HISTORIC PRESERVATION ADVISORY BOARD APPLICATION

Address 109 Saint Mary Street Rockwall TX 75087
 Subdivision Lot A Block 117

**CITY OF ROCKWALL
HISTORIC PRESERVATION ADVISORY BOARD (HPAB) CASE MEMO**

AGENDA ITEM: H2017-016; COA for 109 St. Mary Street

Proposed Idea 2nd level deck and railing

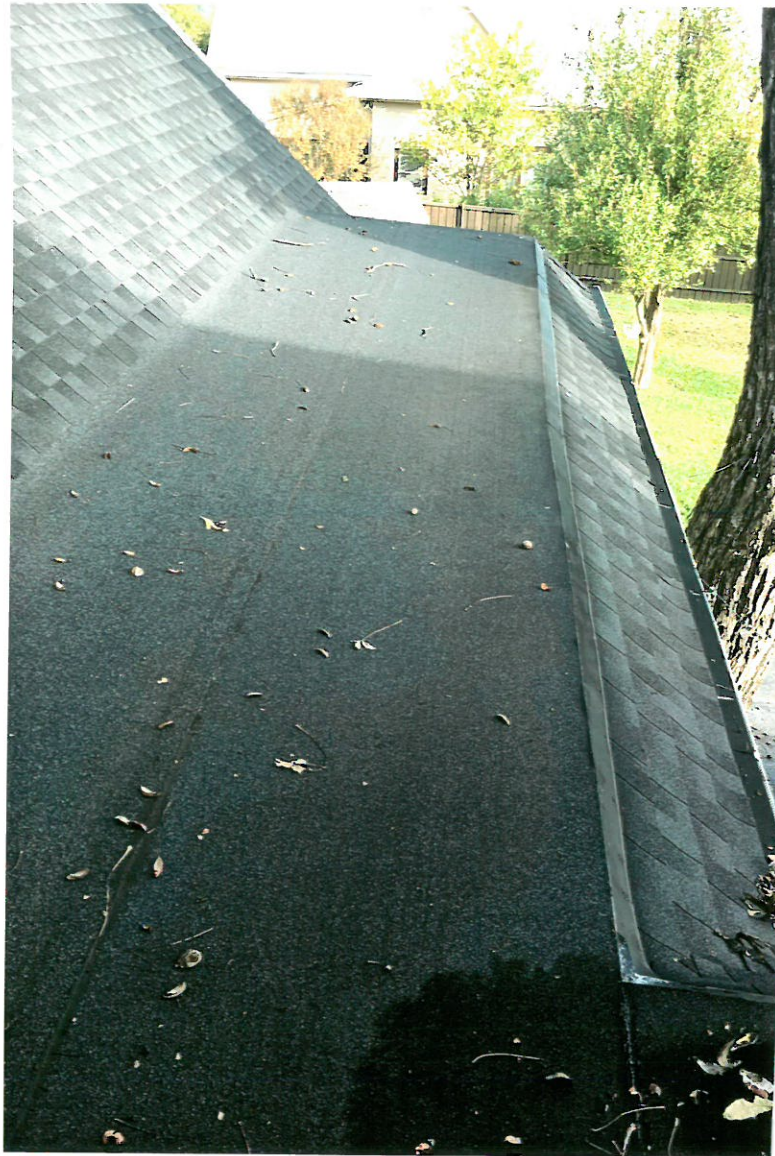
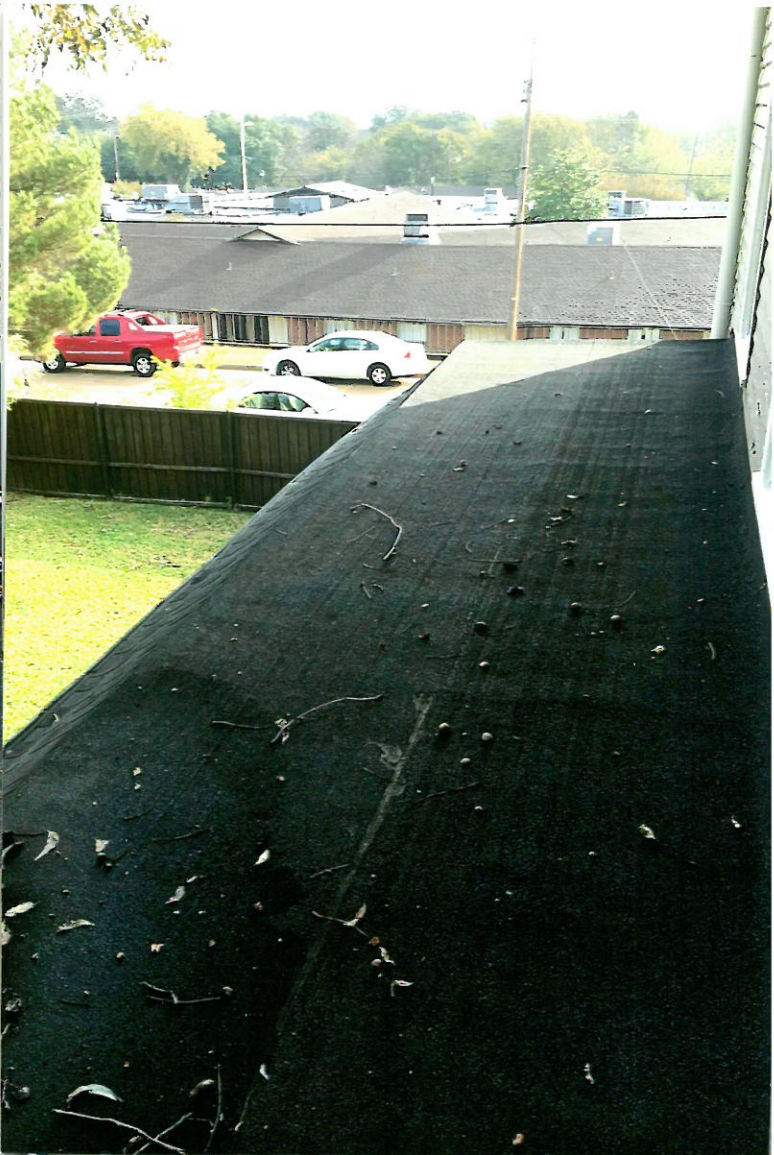
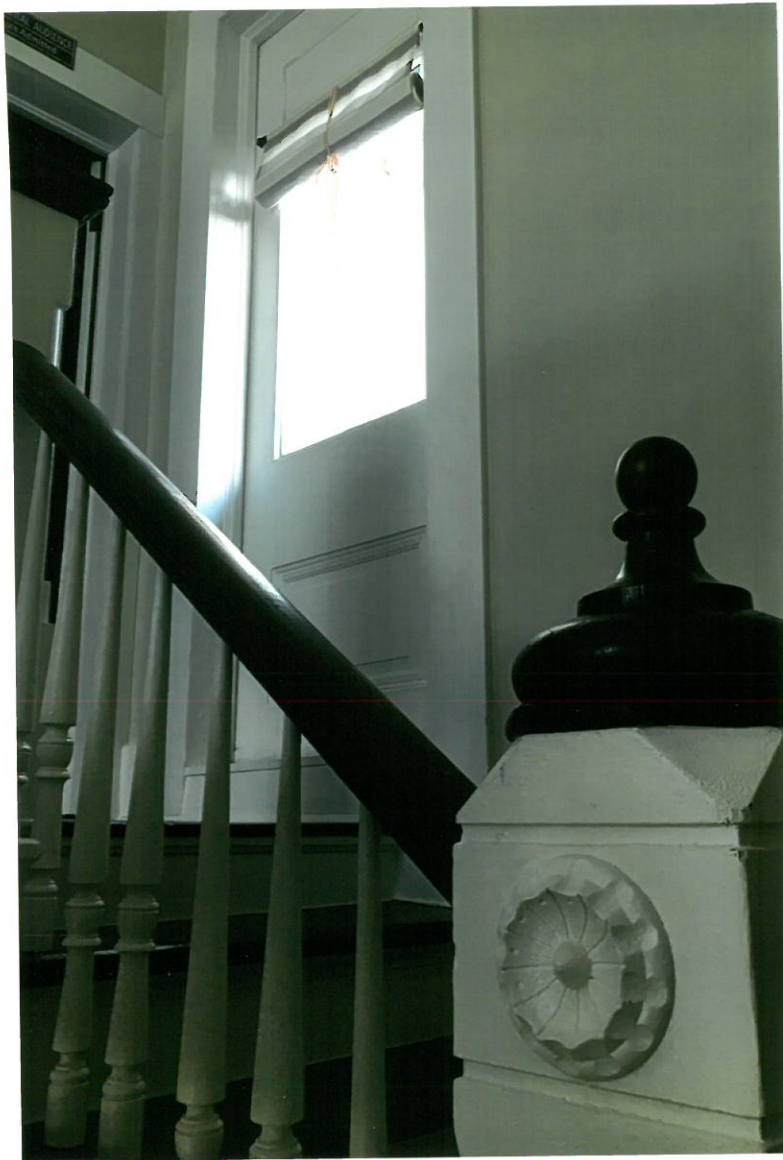
- *Construction.* Materials, structural and decorative elements and the manner in which they are used, applied or joined together should be typical of the style and period of the existing structure. New additions, alterations and new construction should be visually compatible with neighboring historic buildings or structures. *The applicants are proposing to utilize railing that is similar to the existing galvanized steel railing on the first floor of the home.*
